Mask Set Errata 1

MMC2107 32-Bit Microcontroller Unit

- K61K

Figure 1. Timer

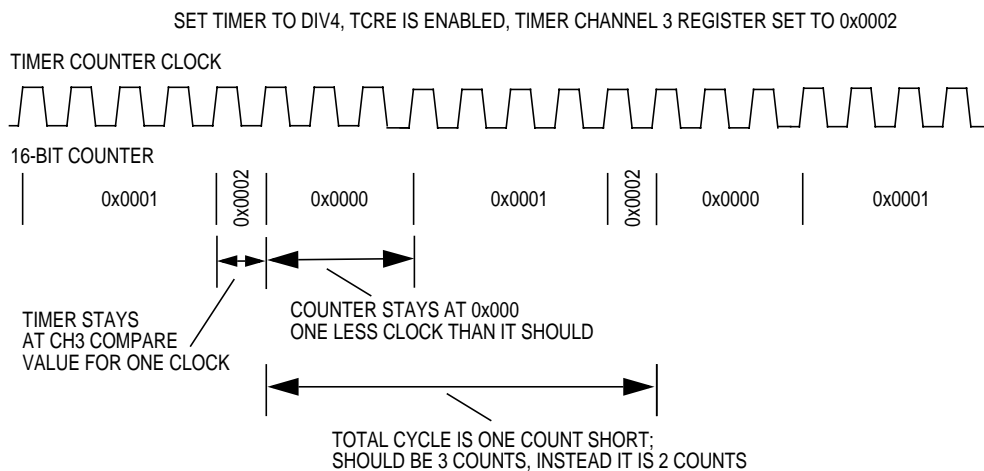
When the TCRE (timer counter reset enable) bit is set, the counter only stays at the channel 3 compare value for one timer clock cycle and then it resets to 0x0000. The 0x0000 count is then one timer counter clock cycle short. (for example, three clocks for div 4). The picture shows what happens for div 4, TCRE enabled and the timer channel 3 register set to 0x0002. See **Figure 1**.

The net result is that you lose a count in the whole repeating loop. The repeating loop is only two timer counter counts long instead of three.

Make the channel 3 compare value one larger to account for the missing count.
